MARION GENERAL HOSPITAL

Marion General Hospital, NRC Byproduct Materials License Number 13-17956-01, would like list Richard Sanchez, M.D. as the Radiation Safety Officer. Dr. Sanchez is currently listed as an Authorized User on our license and we have enclosed the appropriate Form 313A as well as a memo signed by both management and Dr. Sanchez. Please note that we wish to retain the current RSO, Dr. Bruns, as an Authorized User on the license.

Also, we would like to modify the current Hot Lab at the 441 North Wabash Avenue address of use. Specifically, we would like to make the current Hot Lab into two rooms, one to continue to be utilized as a Hot Lab, the other to be a non-restricted room. A diagram of the proposed setup is enclosed, titled Attachment 9.1. In addition, a close-out survey of the portion of the Hot Lab that is to be non-restricted is enclosed.

Close-out survey of part of the Hot Lab at 441 North Wabash Avenue

Close out map

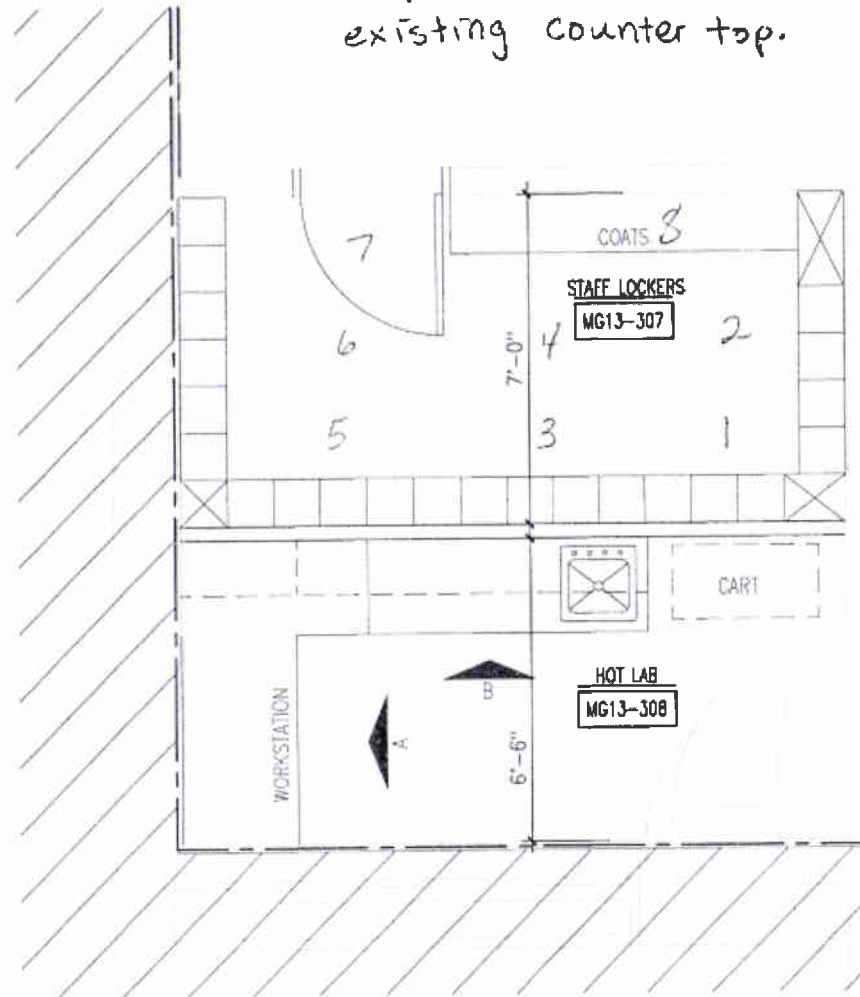
* Numbers refer to locations of wipe samples

* Wipes 7 and 8 were taken on an existing counter top.

Maximum removable contamination occurred in area 7. Gross count rate = 492 cpm/100cm². Net count rate (gross minus background) = 492 – 285 = 207 cpm/100cm². Net removable disintegrations per minute = 207 cpm/100cm² x 1.17 dpm/cpm = 242.2 dpm/100cm².

As of 12/10/08, all radioactive materials have been removed from the area of use and no removable contamination is present.
